City of Broken Arrow

Planning Commission

Thursday, March 14, 2024

Approval of PT-001342-2024|PR-000510-2023, Preliminary Plat, Antler Falls, approximately 46 acres, 149 Lots, A-1 (Agricultural) to RS-4 (Single-Family Residential)/PUD-001242-2023 (Planned Unit Development), located south and east of the southeast corner of Houston Street (81st Street) and 257th Street (Midway Road)

CONCEPTUAL IMPROVEMENTS PLAN ANTLER FALLS

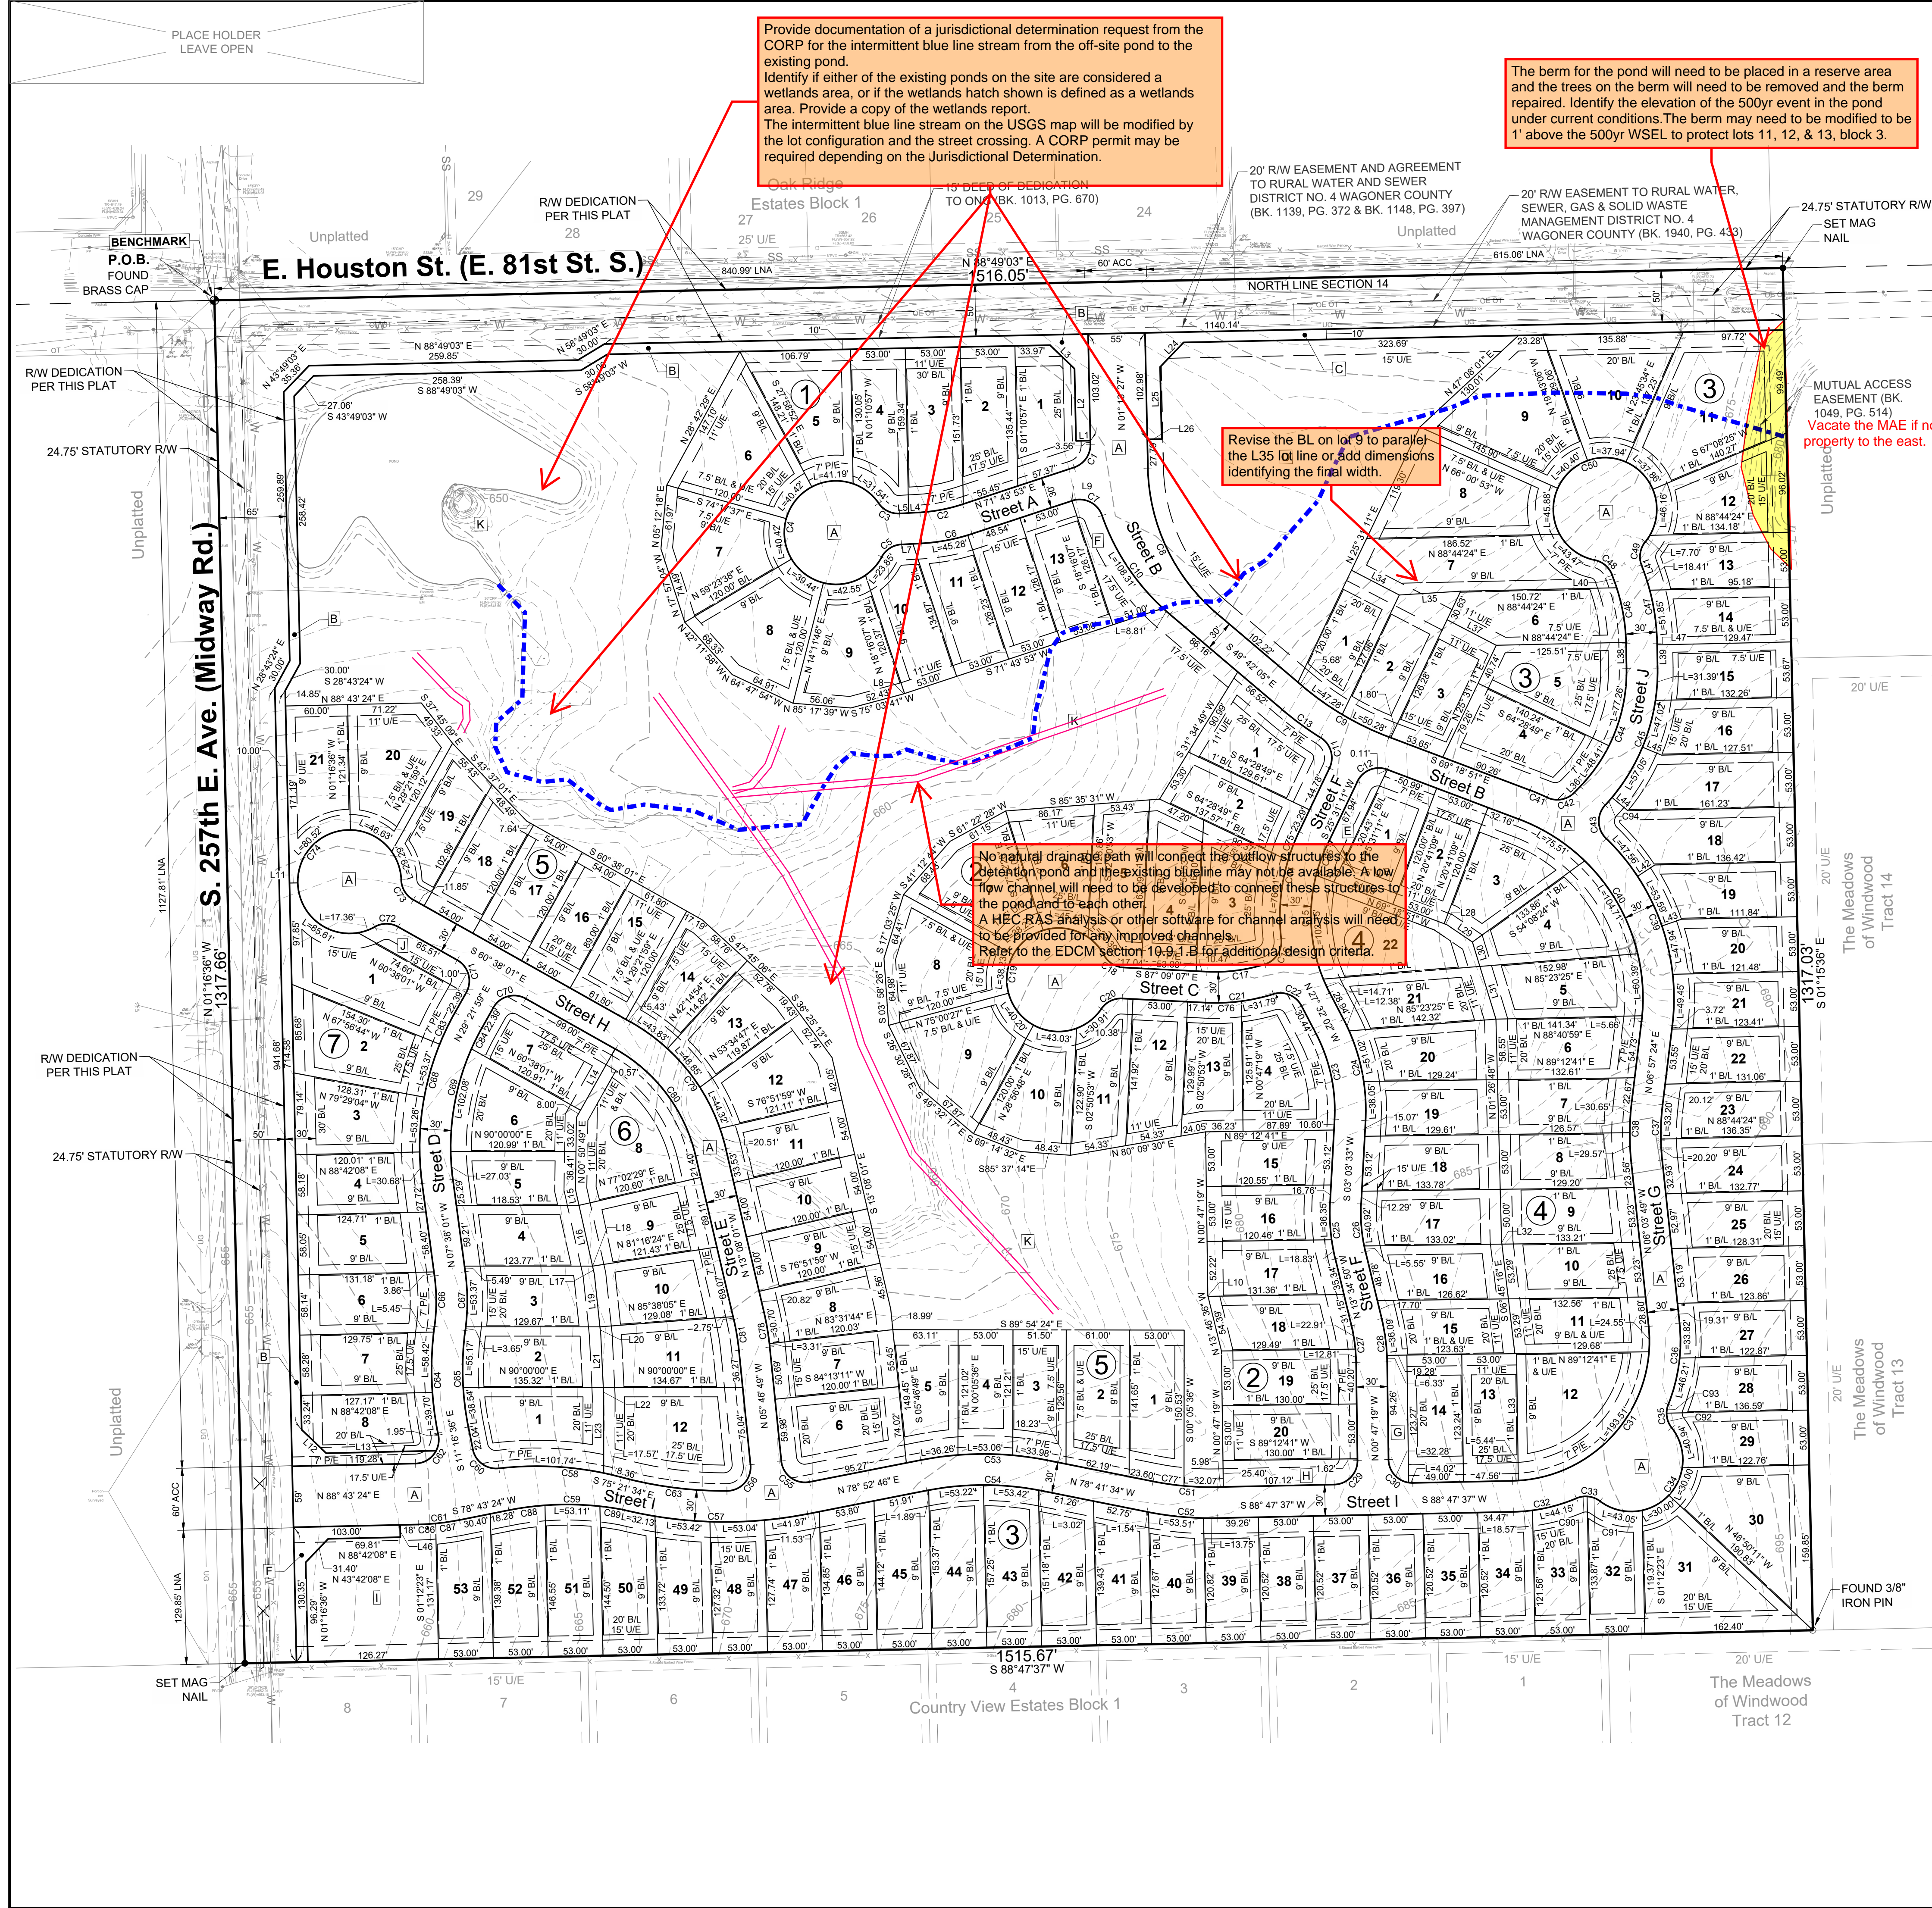
A storm sewer crossing will be needed under the entry with the channel modifications (1)

A storm sewer crossing will be needed under the entry with the channel modifications

ADA ramps will be constructed by the developer and need to be show crossing perpendicular to the centerline of the street. The corner crossing are allowed only after the other options are exhausted. This may require the sidewalk to partially extend along the street to be crossed.

ADA ramps will be constructed by the developer and need to be show crossing perpendicular to the centerline of the street. The corner crossing are allowed only after the other options are exhausted. This may require the sidewalk to partially extend along the street to be crossed.

Flow from the estates at ridgewood south is projected to overtop the road at the drive on the north side of the street. The flow is shown to be approximately 115 cfs. This flow will need to be taken into account in the stormwater analysis through the site and along Houston. The existing roadside ditch will not handle the 100yr flow and will need to be modified to carry any flow that does not flow through the site. A variance will be needed for any proposed channel along Houston that does not carry the 100yr event

No acute angles between pipes are allowed in the manhole. Revise the angle between the two pipes to be a minimum of 90 degrees

Page Label: [7] 2340719 Preliminary Plat-Sheet 1 (CIP) Author: jdickeson	No acute angles between pipes are allowed in the manhole. Revise the angle between the two pipes to be a minimum of 90 degrees. Show the location of the tees for each lot. No service line are allowed to connect into a manhole and there needs to be a minimum of 5' between the outside edge of the manhole and the center of the tee. The configuration show may not provide Lot 12 with sanitary sewer access without crossing more than 1 property line. Service lines cannot cross multiple lot lines to access the main line.
---	---	---

Revise the sanitary sewer to be in the easement and not in the reserve area. The primary location is in the easement, the secondary location may be in the reserve with a valid engineering reason.

Show the outflow structure and the overflow weir

Show the sanitary sewer within the U/E, the sanitary may be placed in the reserve if there is a valid engineering reason that the line cannot be placed in the U/E (typ for all sanitary sewer lines)

Verify that the pipe from the upstream inlet will not enter the downstream structure through a corner

Where the sanitary sewer is present the U/E configuration for a side yard/back yard needs to be in an standard 11'/11' configuration with the sewer in the correct location in the south easement.

Show the outflow structure and the overflow weir

A storm sewer crossing will be needed under the entry with the channel modifications

Flow from the estates at Ridgewood south is projected to overtop the road at the drive on the north side of the street. The flow is shown to be approximately 115 cfs. This flow will need to be taken into account in the stormwater analysis through the site and along Houston. The existing roadside ditch will not handle the 100yr flow and will need to be modified to carry any flow that does not flow through the site. A variance will be needed for any proposed channel along Houston that does not carry the 100yr event

The sidewalk will need to extend to the street and show 1 crossing for each direction.

Where the sanitary sewer is present the U/E configuration for a side yard/back yard needs to be in an standard 11'/11' configuration with the sewer in the correct location in the south easement.

No acute angles between pipes are allowed in the manhole. Revise the angle between the two pipes to be a minimum of 90 degrees.
Show the location of the tees for each lot. No service line are allowed to connect into a manhole and there needs to be a minimum of 5' between the outside edge of the manhole and the center of the tee. The configuration show may not provide Lot 12 with sanitary sewer access without crossing more than 1 property line. Service lines cannot cross multiple lot lines to access the main line.

Revise the sanitary sewer to be in the easement and not in the reserve area. The primary location is in the easement, the secondary location may be in the reserve with a valid engineering reason.
